City of Lindsay

Hermosa Street/Westwood Avenue Roundabout Landscape Project – No. 1

Addendum/Clarification No. 2

5 MASTER VALVE AND FLOW SENSOR ASSEMBLY
1 1/2" = 1'-0" P-HE-27

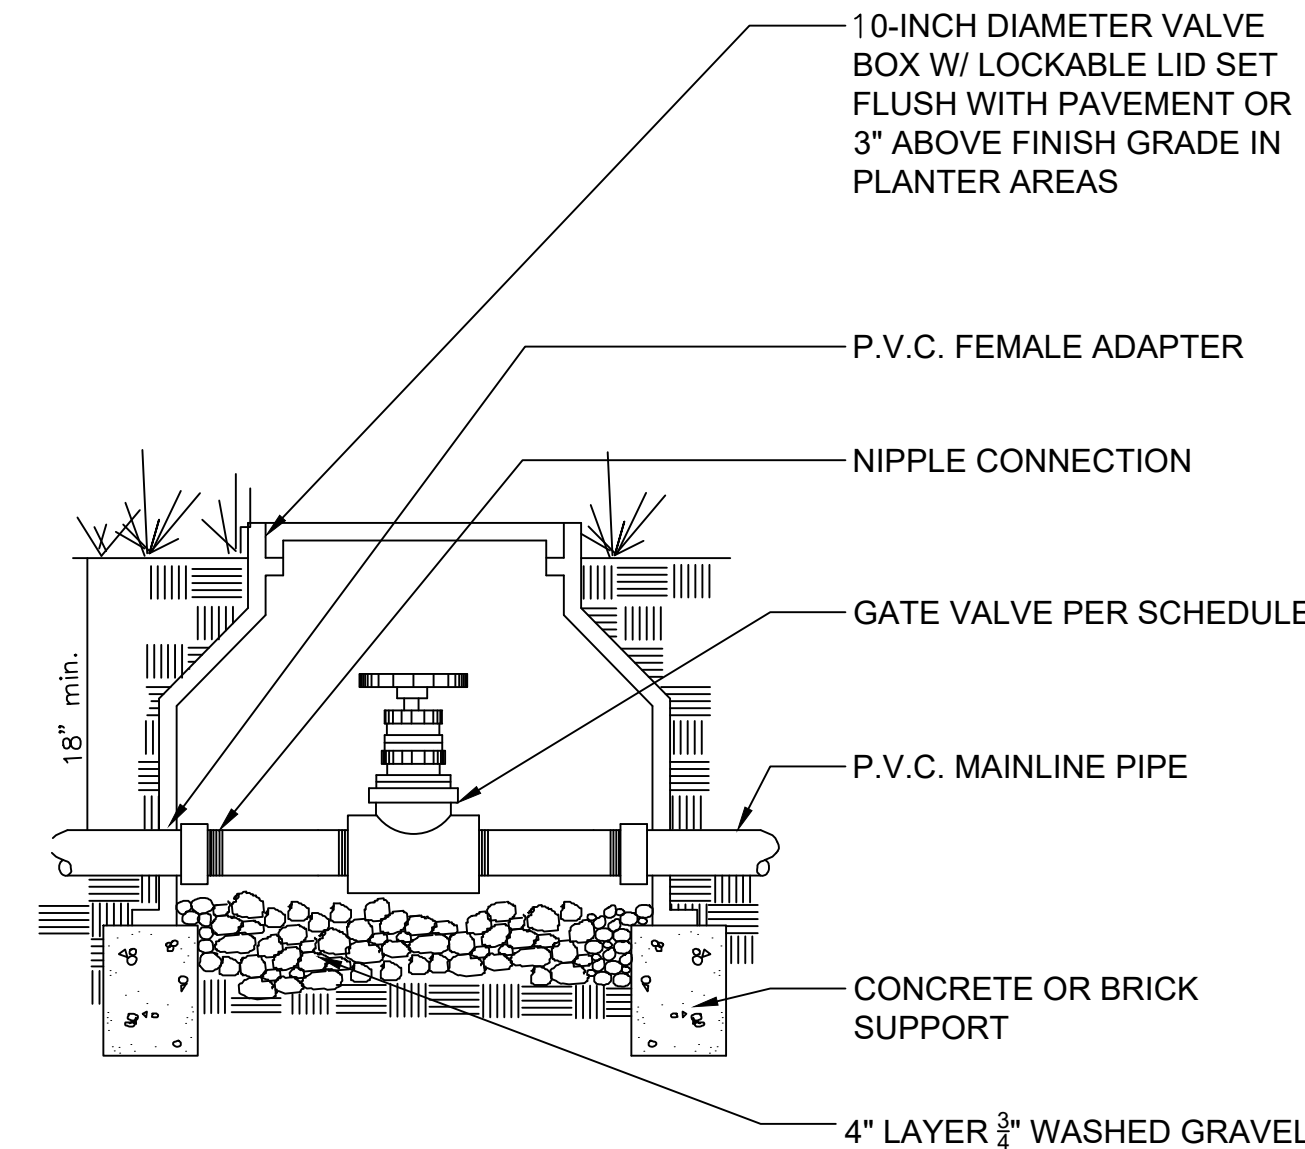
13. Q: Sheet LI5 irrigation specifications require the installation of rectangular Carson valve boxes for proposed valves, details for master valve and flow sensor require concrete boxes, while details for gate valves and quick coupler valves indicate the use of 10" round plastic boxes. Please advise what the valve box requirements will be.

A: Please use Carson or approved equal products to meet the specifications on LI-3, Irrigation Detail 1 with regards to material, size, shape, locking mechanism, and stenciled marking on lid.

4 TYPICAL RAIN BIRD DRIPLINE REQUIREMENTS
N.T.S.

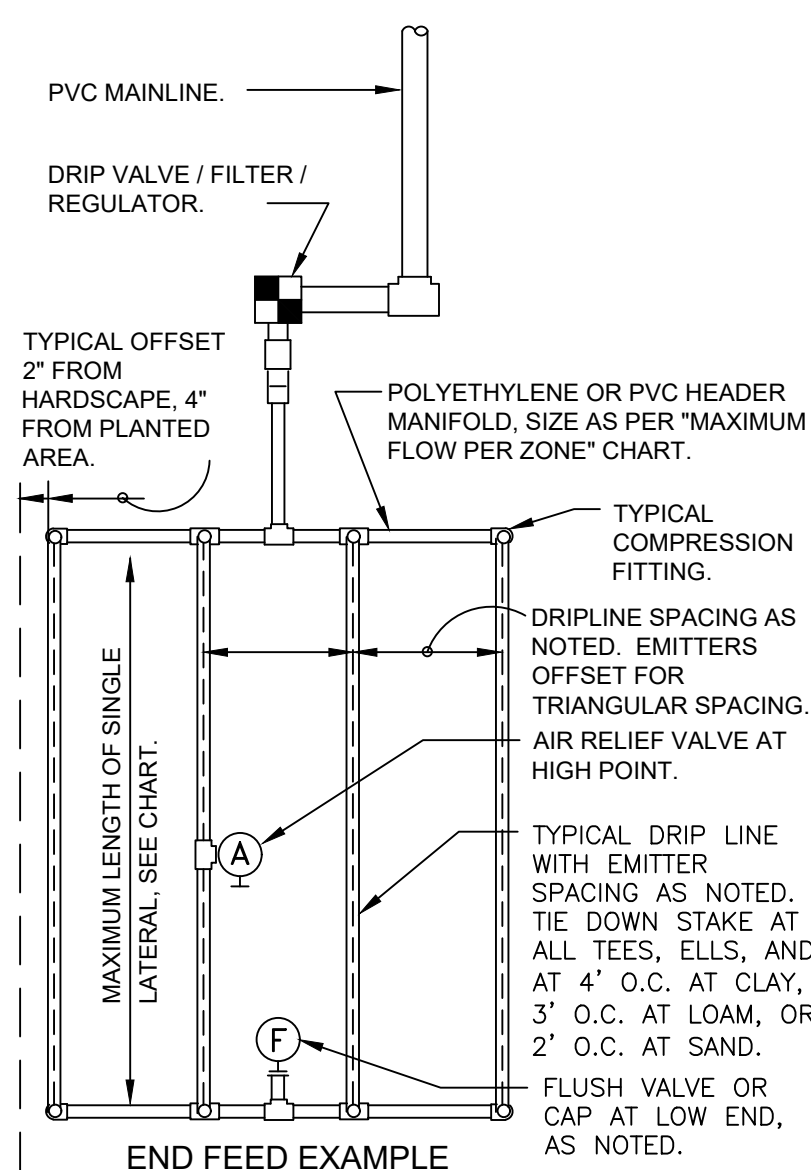
17. Q: The irrigation legend requires the installation of Hunter drip irrigation tubing while the detail refers to Rainbird drip irrigation tubing; please advise which is to be included for bidding purposes.

STREET LIGHTING PLAN
HERMOSA ST/ WESTWOOD AVE ROUNDABOUT
CITY OF LINDSAY
LINDSAY, CALIFORNIA

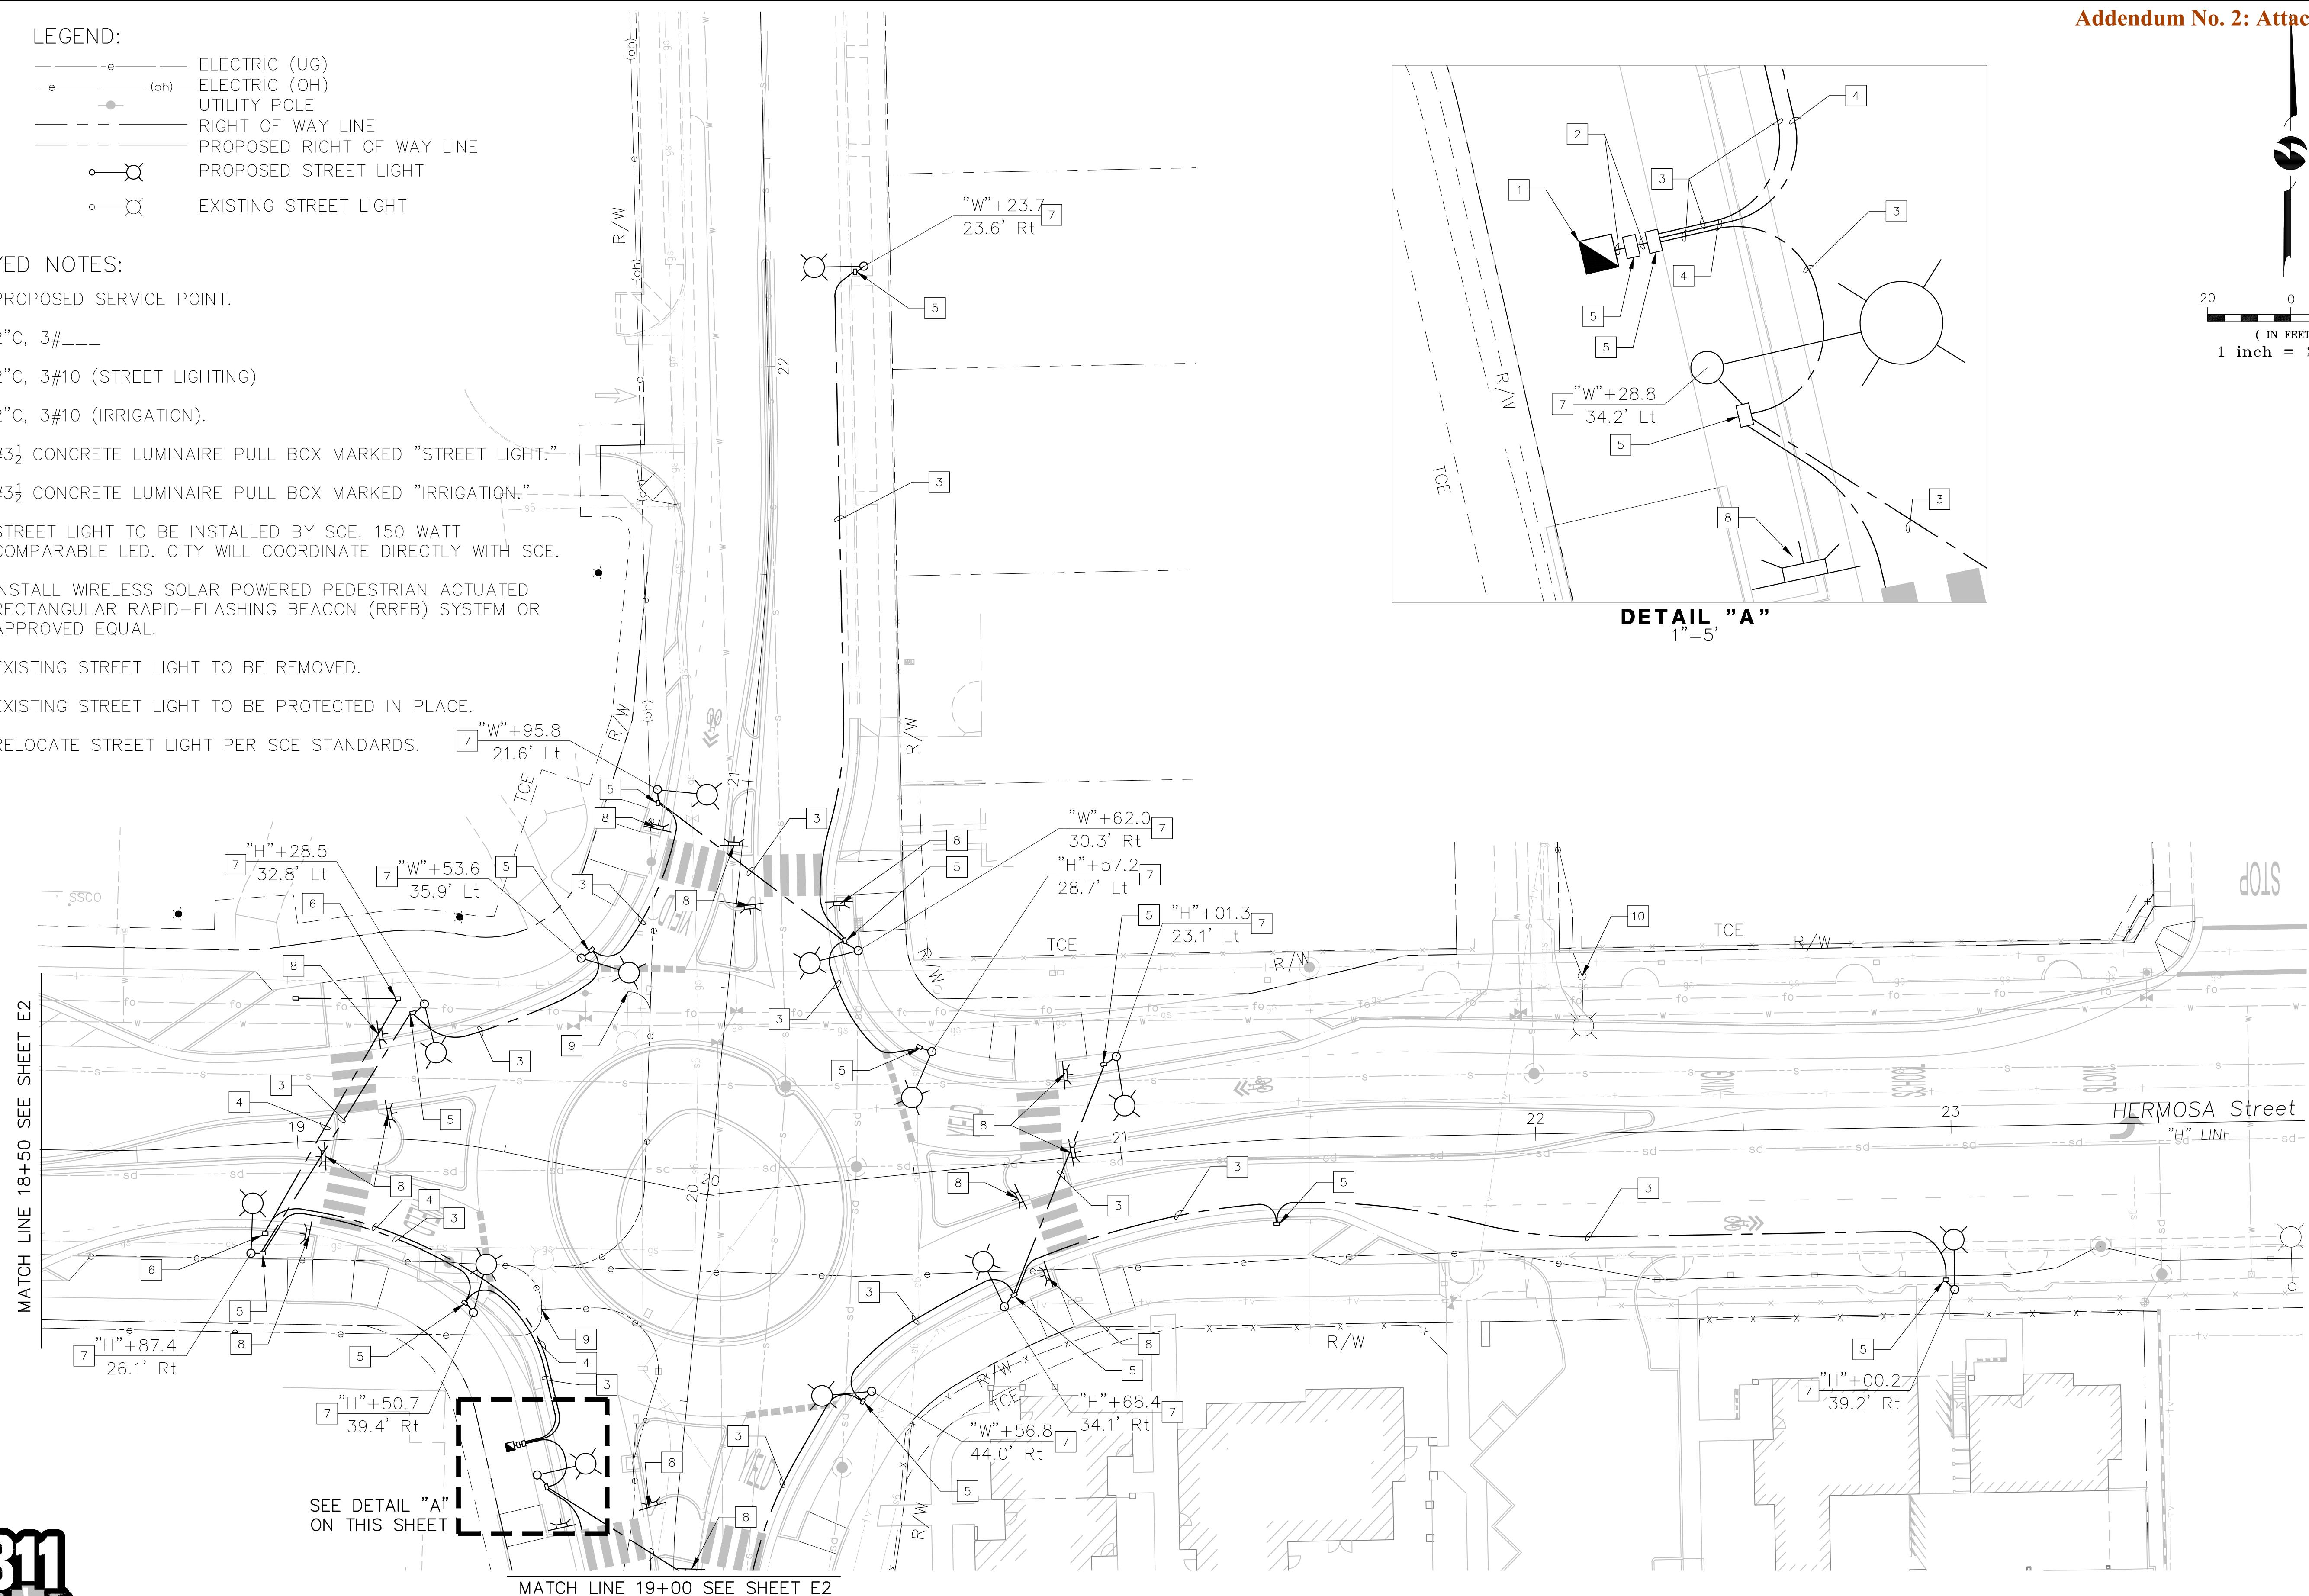
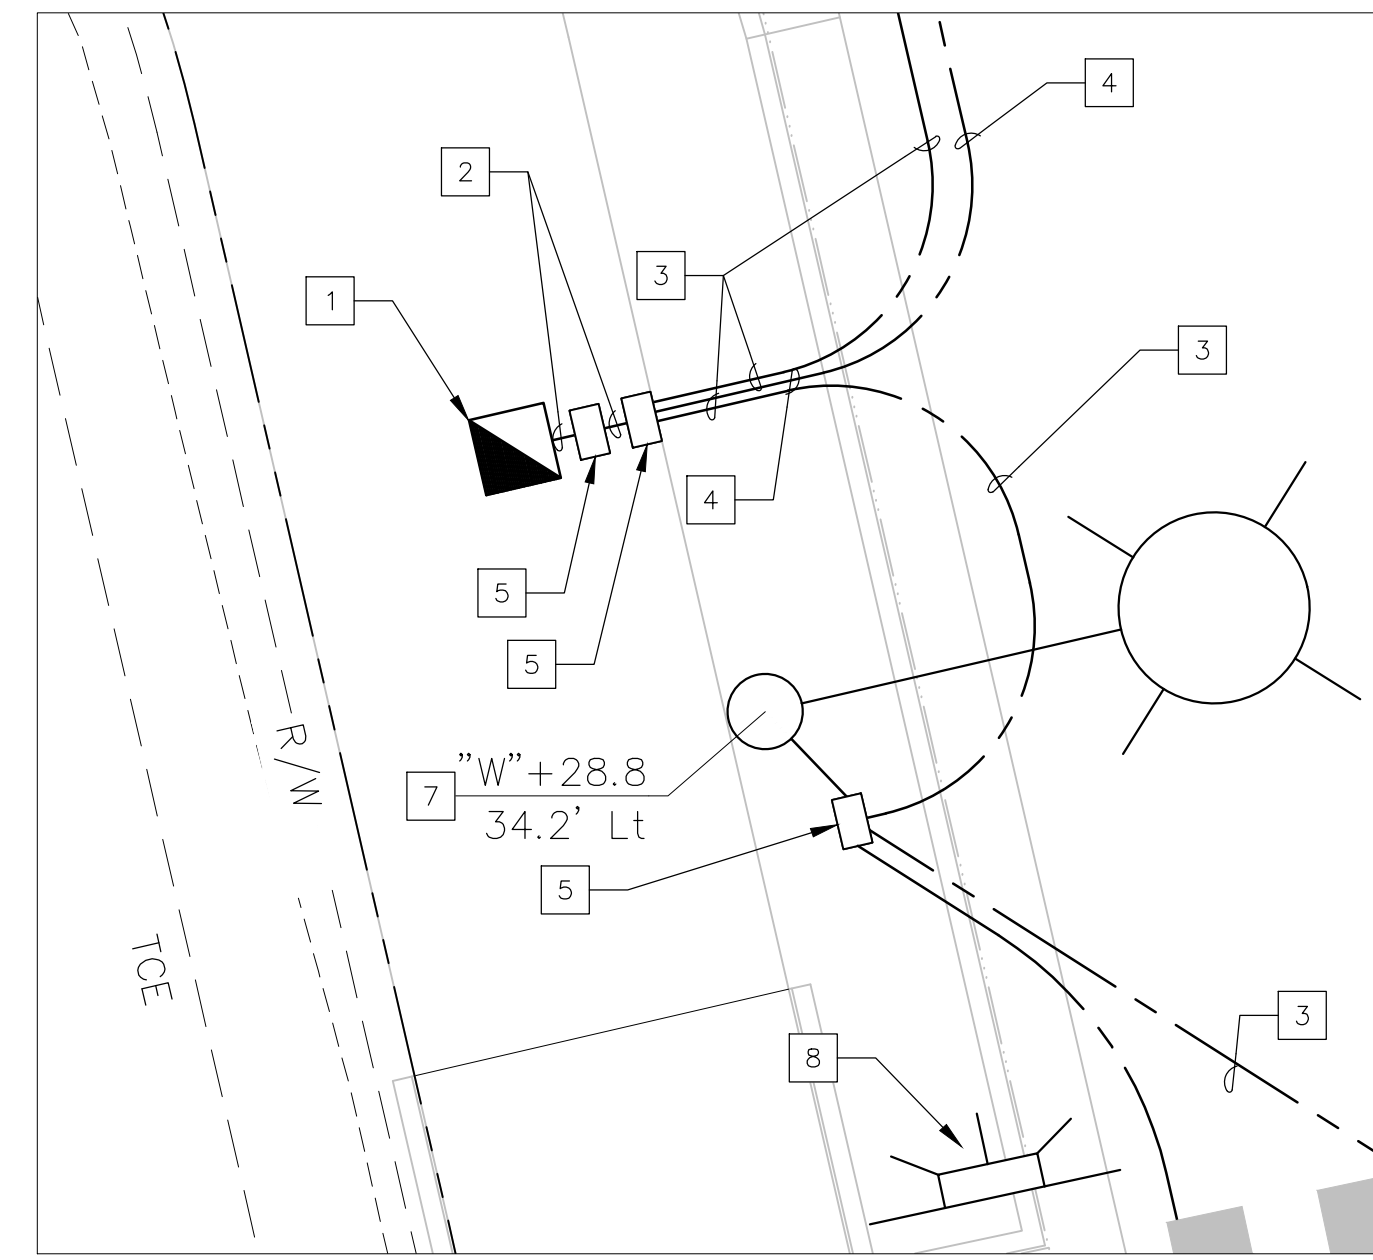
2. Q: Please identify the location of the known power source that will provide permanent electrical connection for the proposed irrigation controller.

A: Please see attached Civil Plans for reference (Addendum No. 2: Attachment #3). The existing power source is identified on the plans.
